Subject: Correspondence received regarding Item #4 – 1075 Pomeroy Avenue Four Units
Development Project

Re: 1075 Pomeroy Avenue, proposed development

I have the following comments and requests regarding the proposed rezoning and development for the 1075 Pomeroy Avenue Property:

Project provides large 2nd floor windows A1 & B1 that are directly opposite 2nd floor windows in the adjacent Pomeroy Green building Q

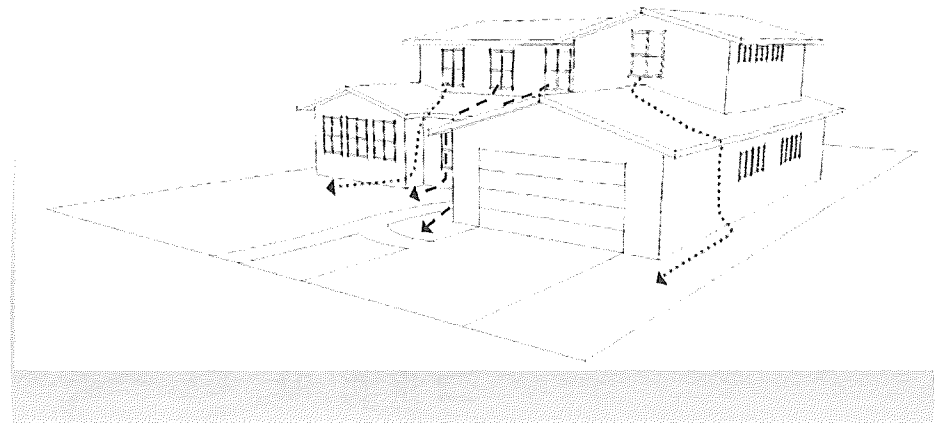
4. Whenever feasible and compatible with the architectural style, avoid window placement in locations that look directly into adjacent neighbor's space or active private yard spaces. (Figure 2.9) Bad window placement at S/S building A1 & B1

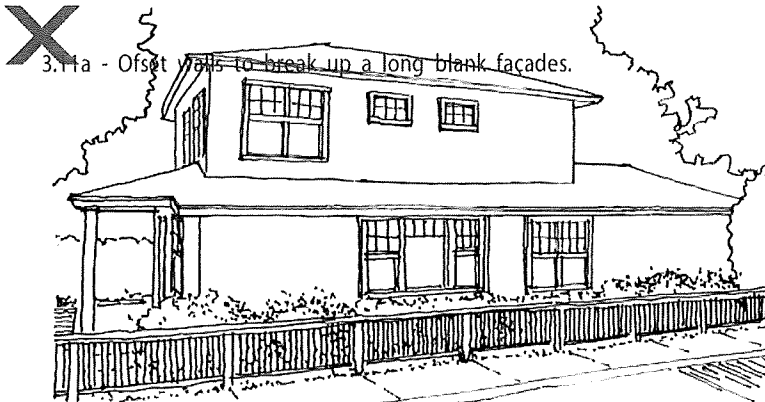
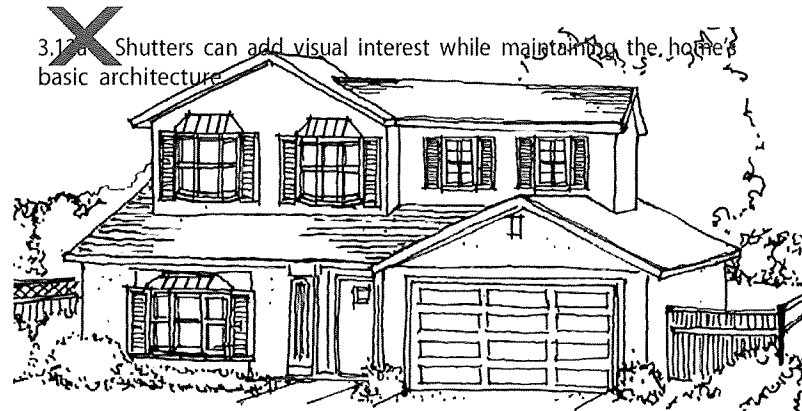
Proposal includes divided light windows, wainscot & horizontal siding that does NOT match surrounding neighborhood.

Site Plan

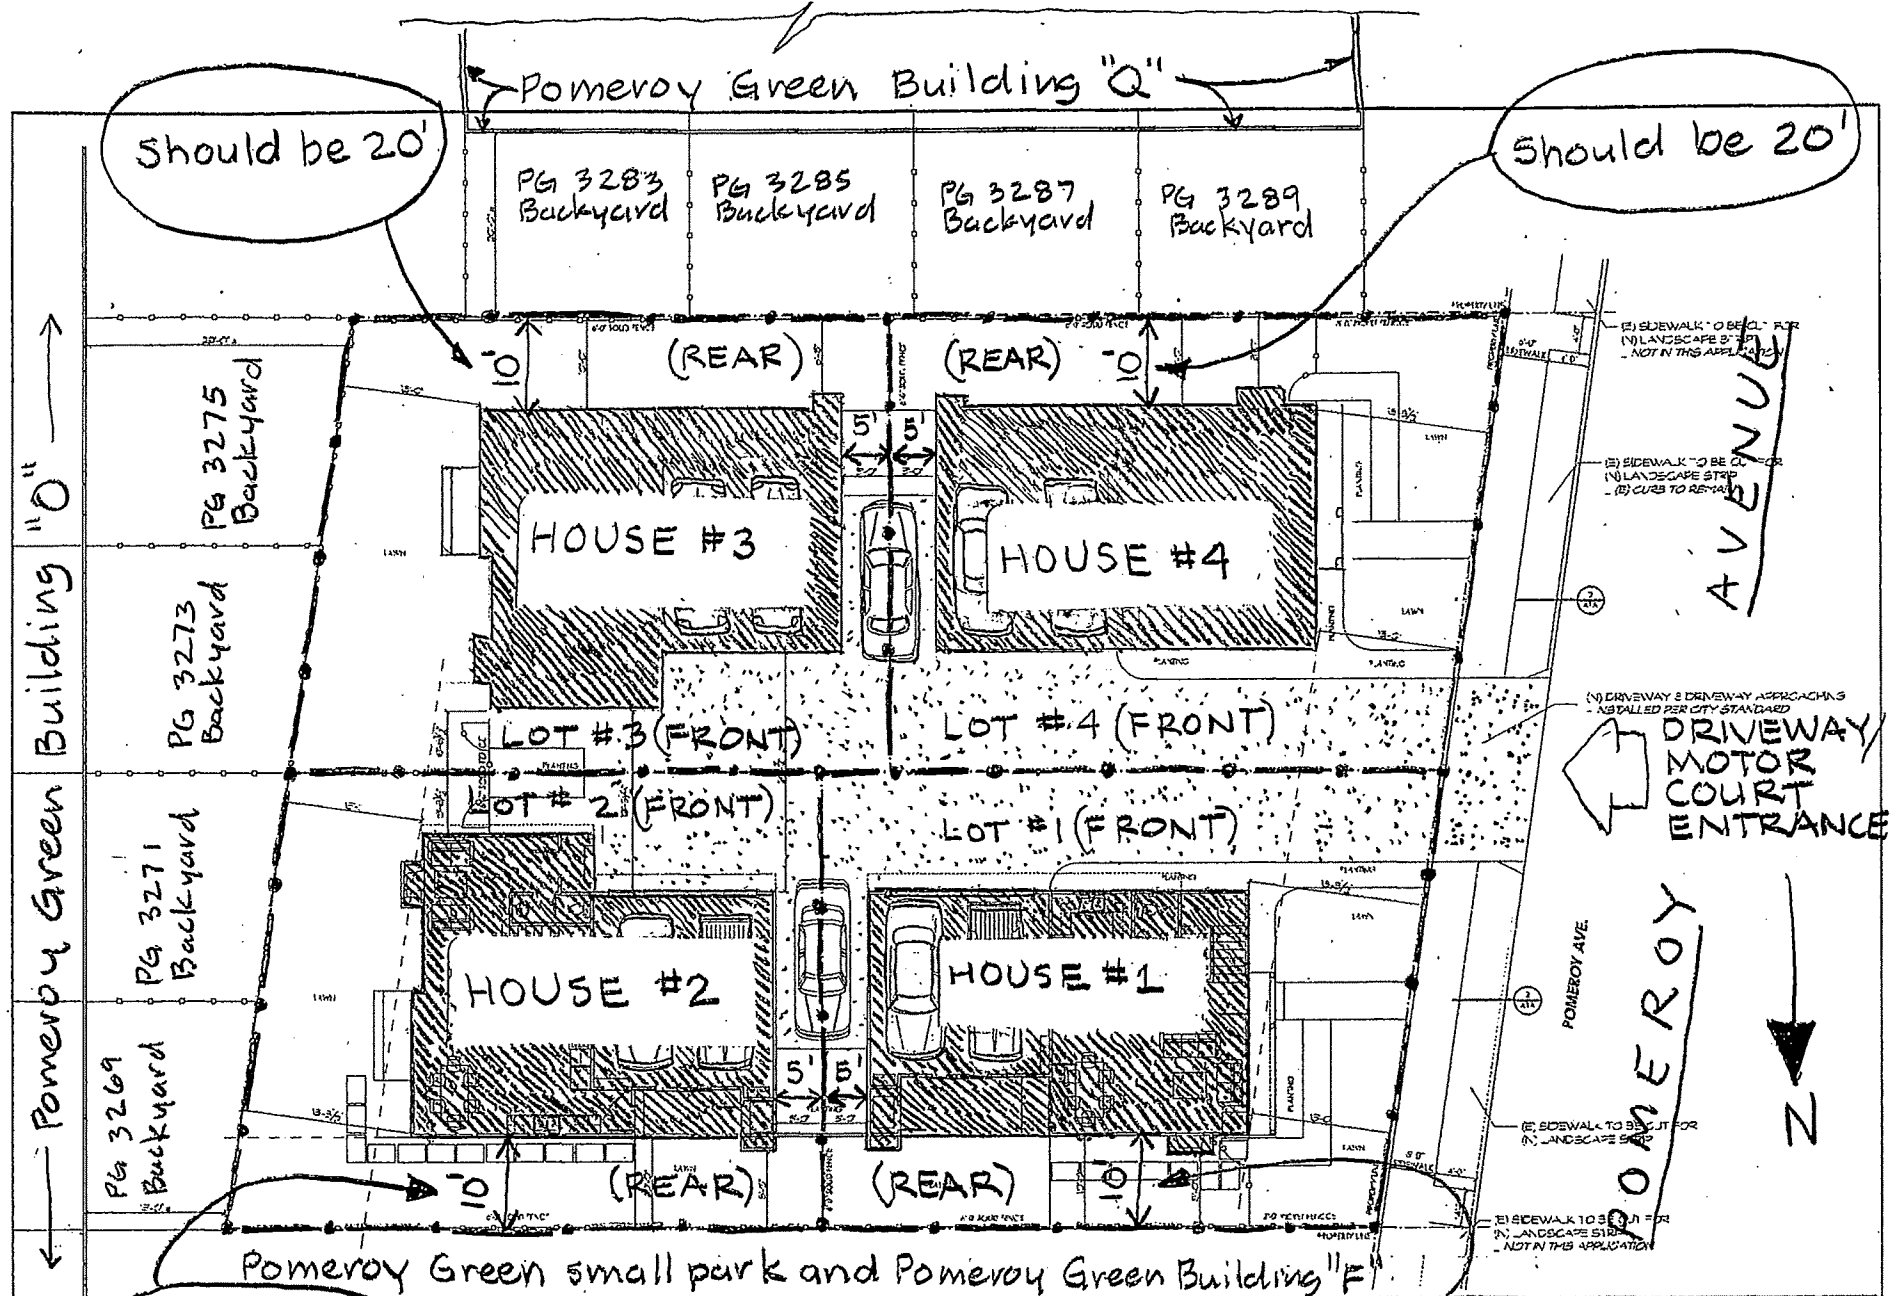
The twenty (20) foot rear setback requirement for the proposed homes would provide the needed privacy between those proposed homes and the adjacent Pomeroy Green townhouses; those townhouses are set back twenty (20) feet from the 1075 property line. With the forty (40) foot separation between the proposed homes and the existing Pomeroy Green townhouses, the level of privacy would be similar to the privacy provided in single-family detached home neighborhoods.

If the twenty (20) foot rear setback is applied to the developer's proposal, the width of the central driveway/motor court would be reduced to the width of a sidewalk (6'-2" wide); therefore, the developer's proposed motor court becomes unfeasible.
